# ADA Curb Ramp New Construction Inspection Form (Perpendicular)

Nw 288 ter

24952.54

Nw mays st

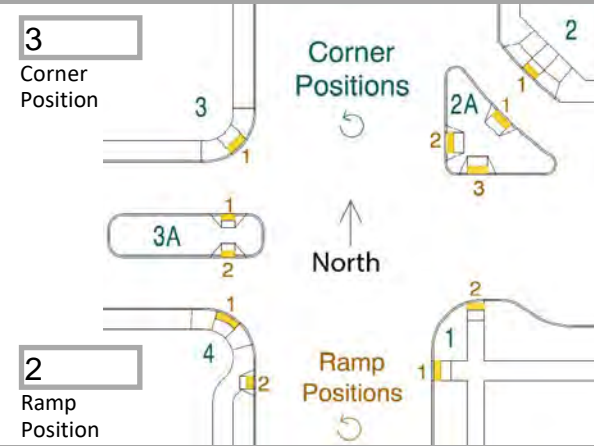
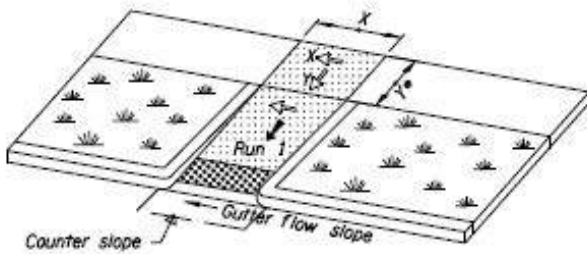
IITD standing water in gutter
